WOODMEN FRONTAGE ROAD TURN LANE

PUBLIC IMPROVEMENT CONSTRUCTION PLANS

PCD FILING NO. CDR-21-18

DETAIL GRADING PLAN

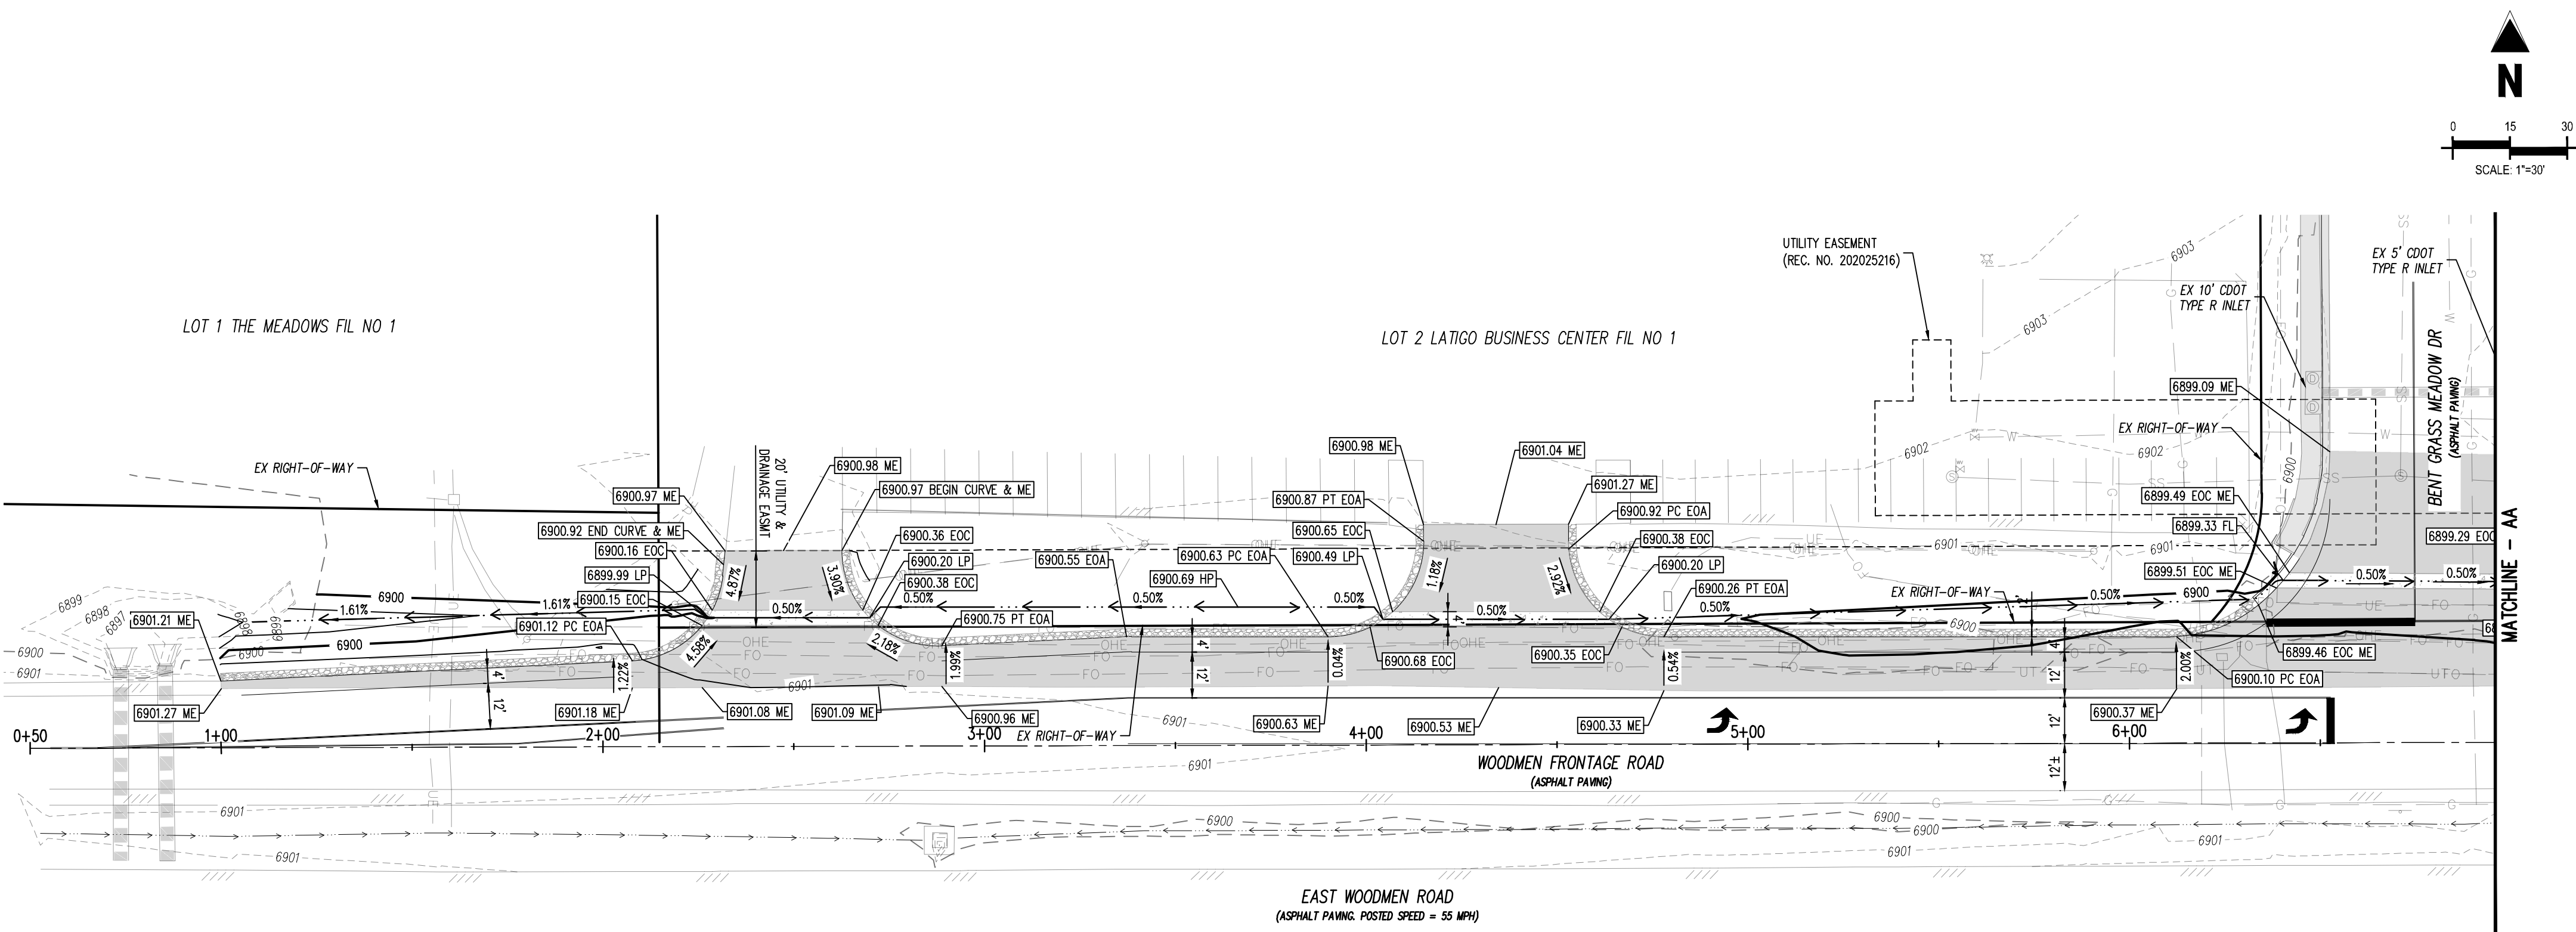
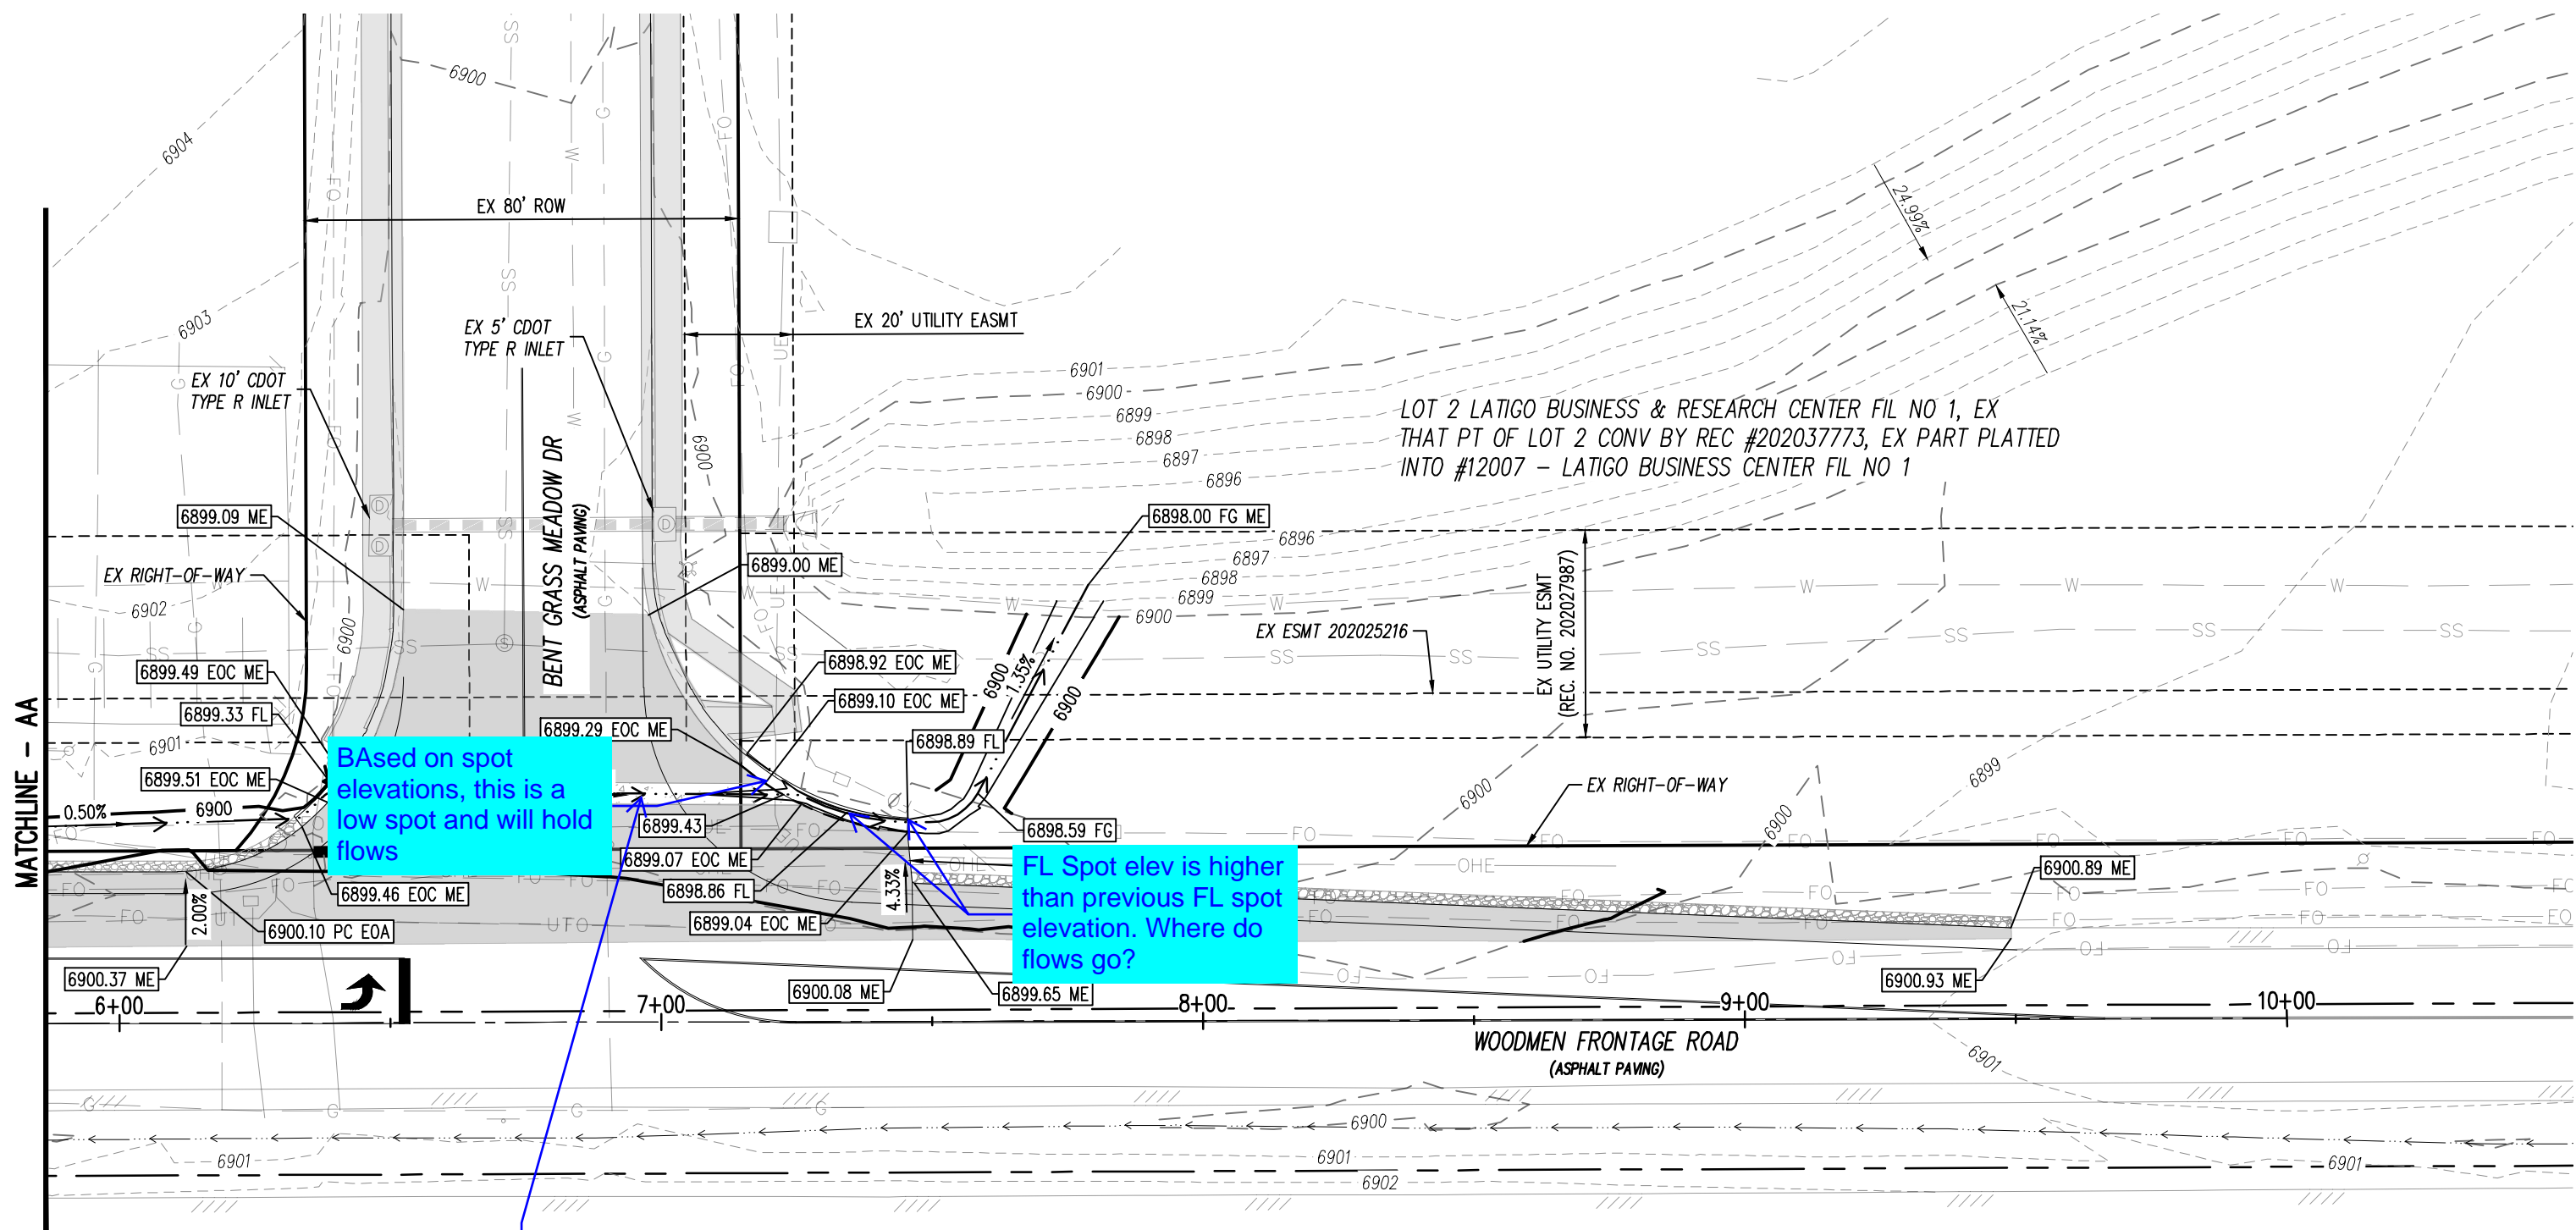
use standard EPC
8' cross pan
